# DESERT BREEZE SOLAR PROJECT

## FINAL ENVIRONMENTAL IMPACT REPORT

SCH# 2022090646

JANUARY 5, 2024

**REVISED FIGURE 3-5: Land Use**

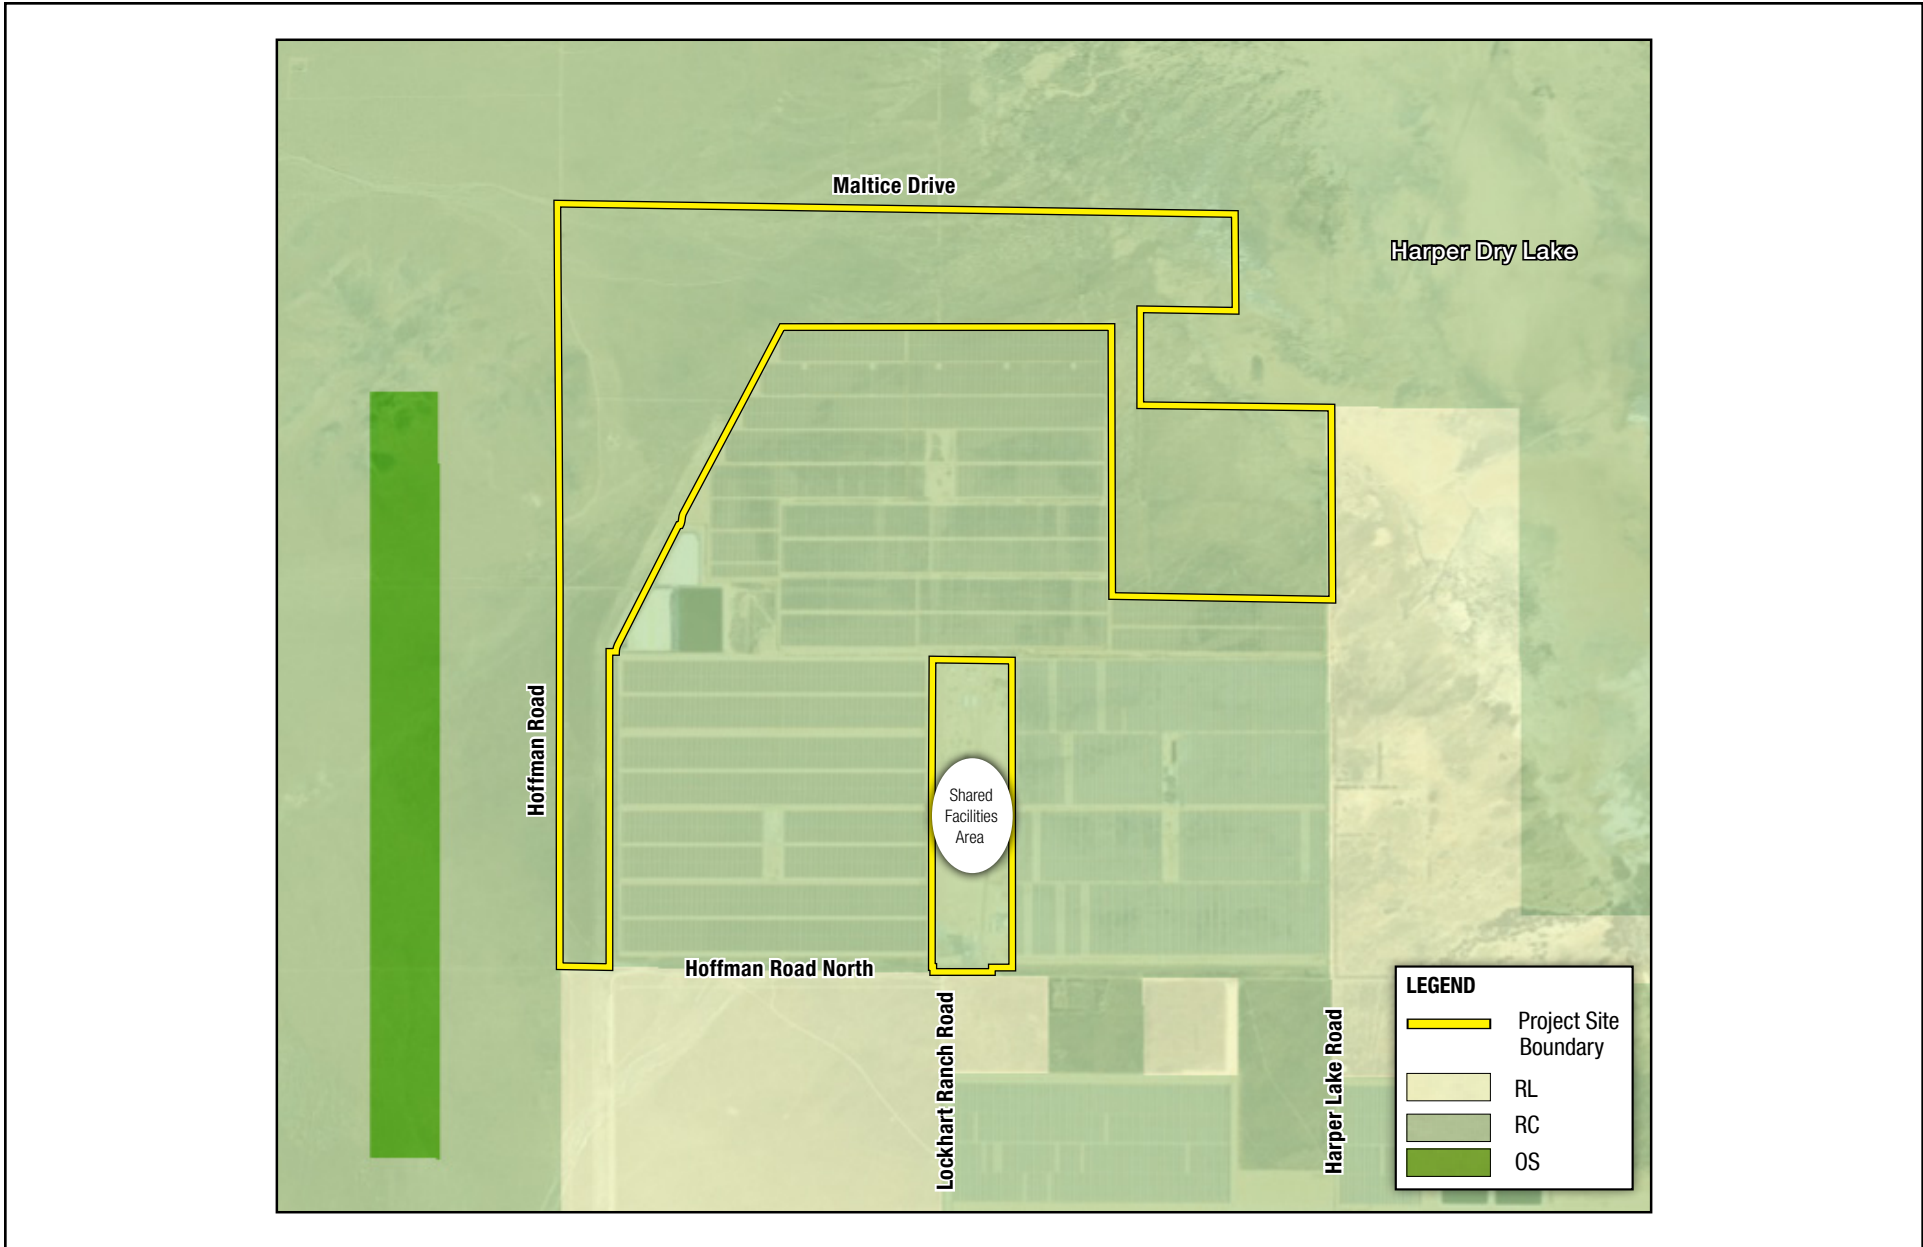
4. Page 3-9, **Figure 3-5: Land Use** is revised below.

The Project includes a request for a Project-specific zone change from RL to RC for the solar array area of the Project Site. The Project is subject to CUP approval in the RC zone. For the purpose of power distribution to multiple receiving customers and for specific entity management of the BESS and Project components (e.g., solar arrays), the Applicant is requesting two CUPs for review and approval, see **Figure 3-7: Conditional Use Permit Areas**).
